XPROG-m Errata Sheet 001

- 1-002-0017 programming adapter Rev.B or earlier

STEP1

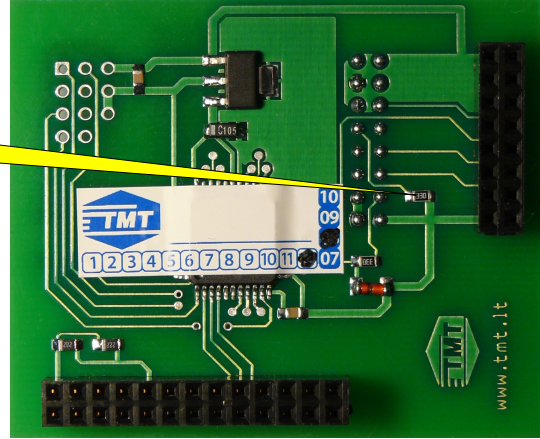
Remove this resistor

STEP2

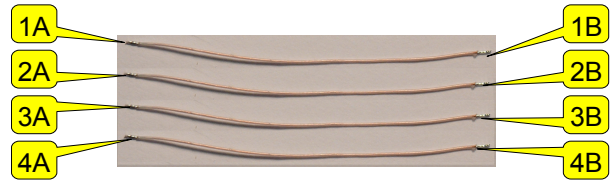
- Prepare the four wires. About 5cm in length.

STEP3

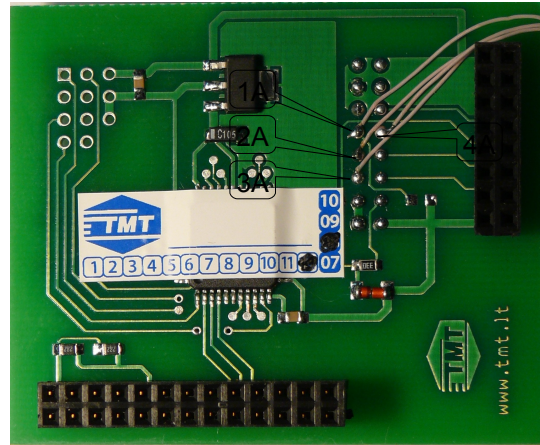
- Solder wire shown in the corresponding points at the bottom side
